December 15, 2004

RESPONSE TO QUESTIONS RAISED BY RIVERKEEPER, INC.

REGARDING SEISMIC HAZARD ANALYSIS AT

INDIAN POINT NUCLEAR GENERATING UNIT NOS. 2 AND 3

Figure 1. Earthquake activities near Indian Point since 1974. Historical earthquake epicenters are based on FSAR, 1985.

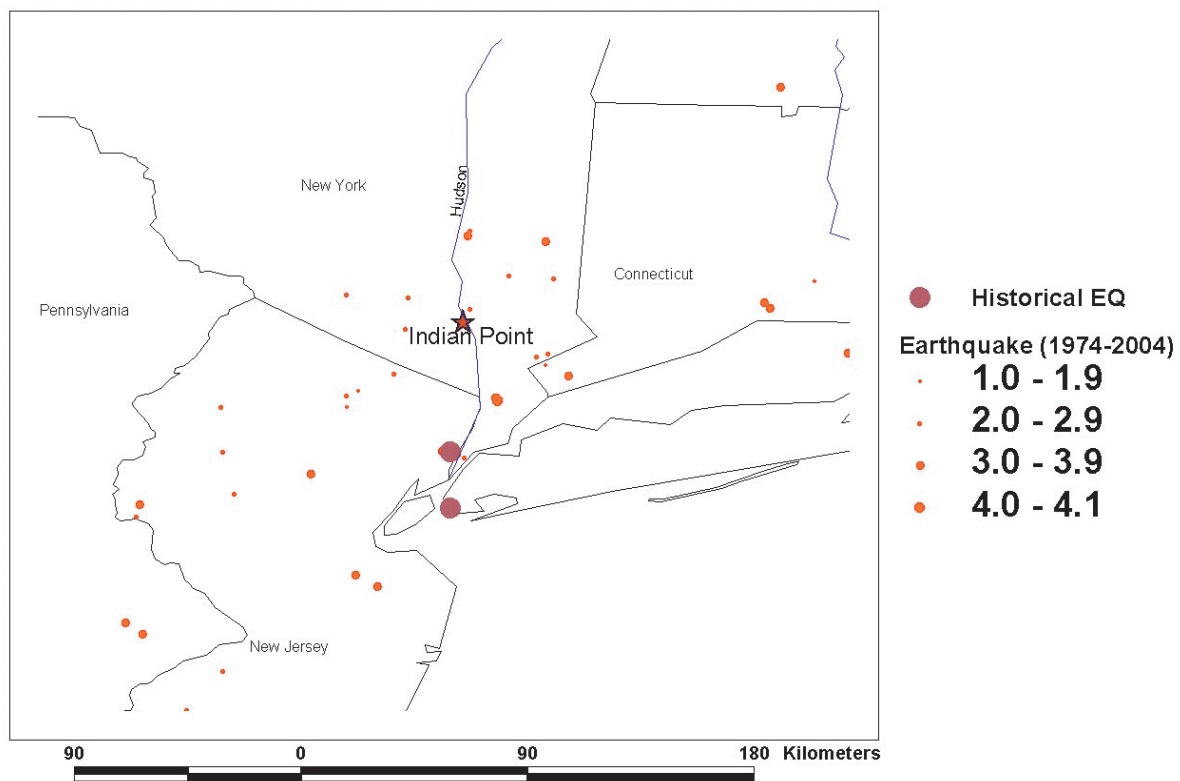
1. A great deal more information on earthquakes has become available since the hazard analysis that was performed decades ago regarding the risk of damage to Indian Point posed by seismic activity. For example, a sequence of earthquakes started in August 2003 is being studied by the Lamont-Doherty Earth Observatory near the New Jersey and Pennsylvania border about 75 miles southwest of Indian Point. These earthquakes are particularly pertinent to the potential for earthquakes near Indian Point because they are associated with the same fault system (the Ramapo fault).

The attached Figure 1 shows the seismic activity, since 1974, in the area within a 200 km radius of Indian Point. There are a total of 63 events that occurred during the period, with magnitudes ranging from 1.1 to 4.1. The earthquake catalog is based on the U.S. Geological Survey (USGS) National Seismic Network. Only two earthquakes have occurred (magnitude 3.8 on August 26, 2003, and magnitude 2.4 on October 1, 2003) near the border between Pennsylvania and New Jersey. There is no obvious earthquake sequence based on the seismic catalog for the border area. Furthermore, these earthquakes are not necessarily associated with the Ramapo fault because the earthquake epicenters project farther north than the fault traces. Earthquakes with magnitudes less than 5 are unlikely to cause any damage to nuclear power plant facilities because of the stringent design requirements for nuclear power plant structures and associated equipment. Larger earthquakes have occurred before 1974 (when seismic instruments were used to register seismic events). The two largest earthquakes, with magnitude of about 5.2, occurred in 1737 and in 1884, respectively, but their locations are uncertain (Figure 1 shows the estimated coordinates provided in Indian Point 2 Updated Final Safety Analysis Report (UFSAR)). Earthquakes of this size, often can cause damage, such as chimney collapse and cracks on the walls in residential buildings, but are unlikely to cause any noticeable damage to a nuclear facility.

Figure 2. Design spectra and potential ground motion at the Indian Point site.

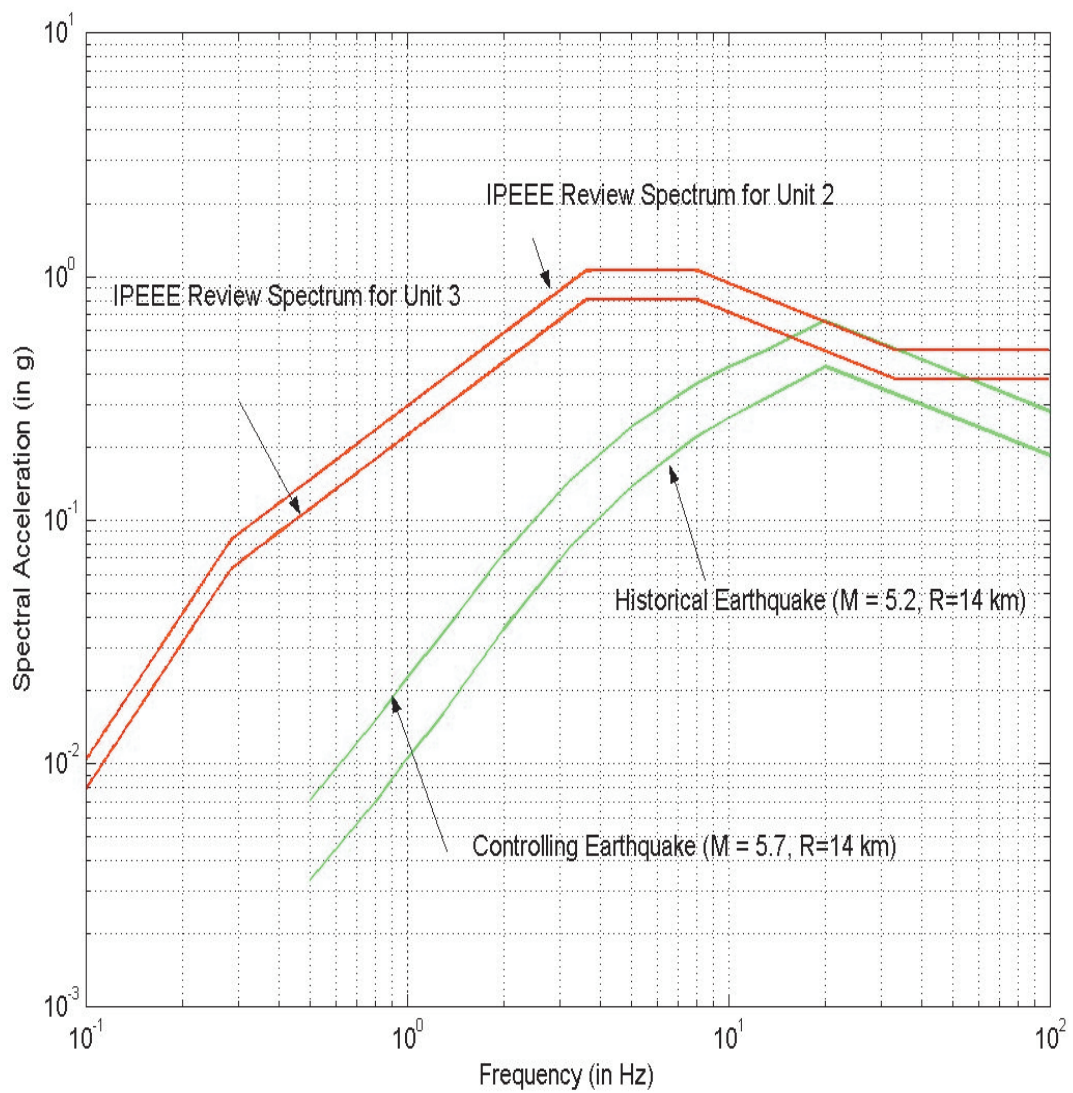
4. But it is obvious that the seismic hazard analysis for Indian Point- which is situated adjacent to the Ramapo fault- clearly needs to be updated.

Figure 2, attached, shows (a) the IPEEE review spectra anchored at 0.5 g and 0.38 g for Units 2 and 3, (b) the controlling earthquake (based on LLNL, magnitude of 5.7 at a epicentral distance of 14 km and assumed depth of 10 km) ground motion spectrum (with a reference probability of 10^{-5}), and (c) the historical earthquake (magnitude of 5.2 at a epicentral distance of 14 km and assumed depth of 10 km) ground motion spectrum. For the ground motion prediction relative to both controlling and historical earthquakes, the NRC staff used an Atkinson and Boore attenuation relationship (Atkinson and Boore, 1995). A comparison of these spectra shows that both the controlling earthquake and the historical earthquake are enveloped by both IPEEE review spectra for Unit 2 and 3 up to about 15 Hz, although IPEEE review spectrum for Unit 3 is lower than controlling earthquake at about 15 Hz. Since the natural frequency range for most structures and equipment at nuclear power plants falls below 10 Hz, ground motions above 15 Hz will not likely damage major structures, systems, and components at Indian Point. High frequency ground motion above 10 Hz generally affects active components such as relays and contacts, which are subject to chatter. Relays and components, with high frequency sensitivity, have been explicitly addressed in IPEEE evaluations.

Figure 3. Au Sable Forks earthquake strong motion records are in agreement with several attenuation relationships (Atkinson and Sonley, 2003). AB95: Atkinson and Boore, 1995; C2002: Campbell 2002; S2002: Somerville, et al. 2002; T97: Toro et al., 1997.

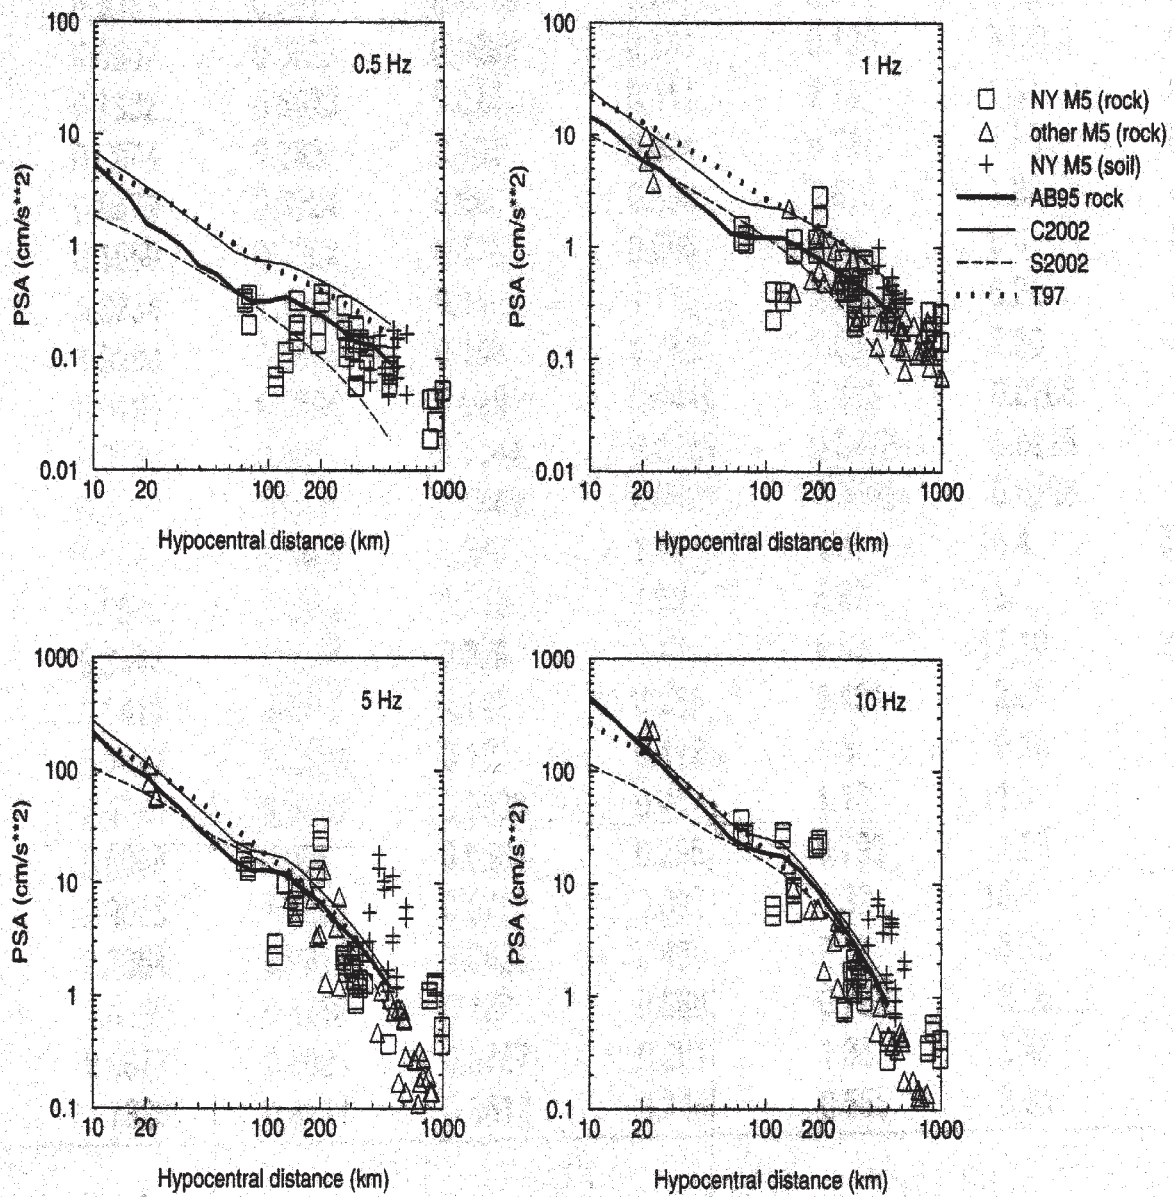
7. New data, for example, are now available for the 2002 Au Sable Forks, Adirondacks NY shock, which was of similar magnitude to the 1884 New York City earthquake.

Strong motion records from one earthquake usually do not significantly change an attenuation relationship. Moreover, seismologists continually update their attenuation relationships, as more strong motion recordings become available. Strong motion data from the Au Sable Forks earthquake had been used in comparing several existing attenuation relationships (Atkinson and Sonley, 2003). The result indicates that the data are in agreement with those attenuation relationships currently used for the CEUS (Figure 3).
